Conservation Resource Center – Plaza and Landscaping Improvements

Invitation to Bid Site Showing Notes – July 24

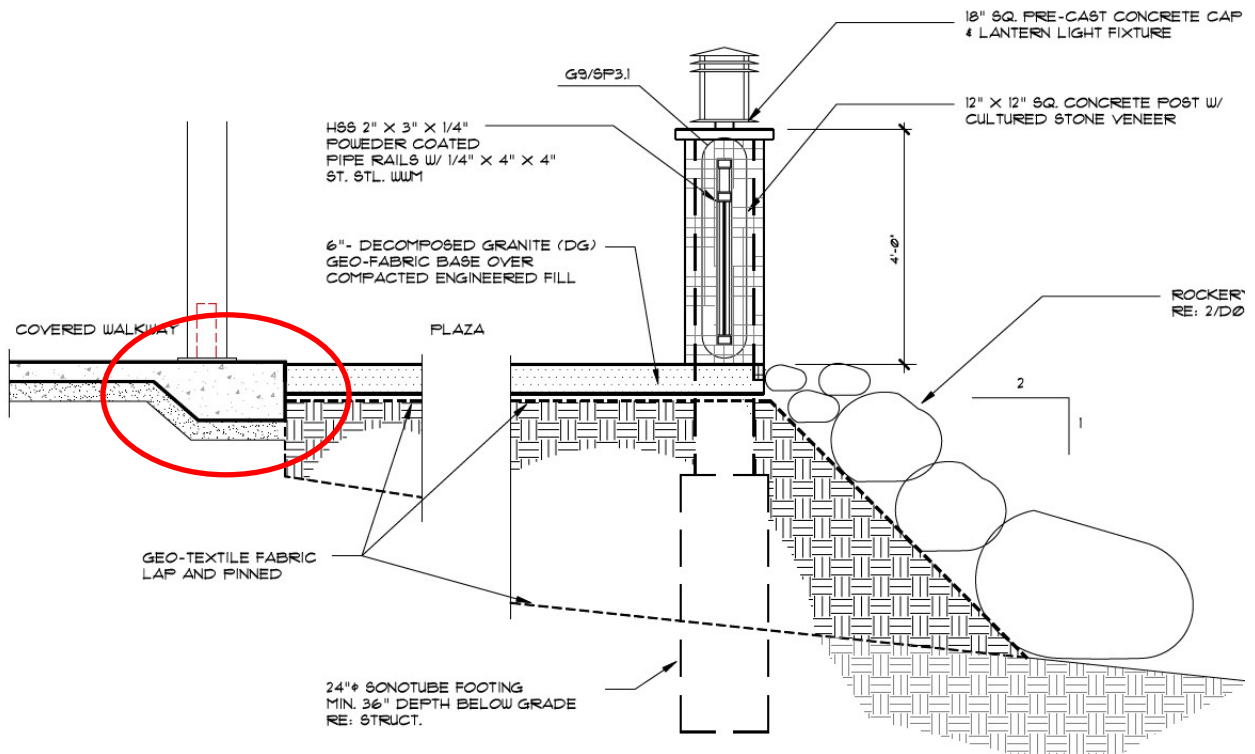
What is the thickness of the existing concrete walkway along the plaza?

The walkway itself is shown in drawings as 4 inches thick, however there is a thickened edge along the plaza edge that supports beams along the walkway that is likely 12 inches thick and may be 18 inches thick. See the area circled in red on the following drawing for detail:
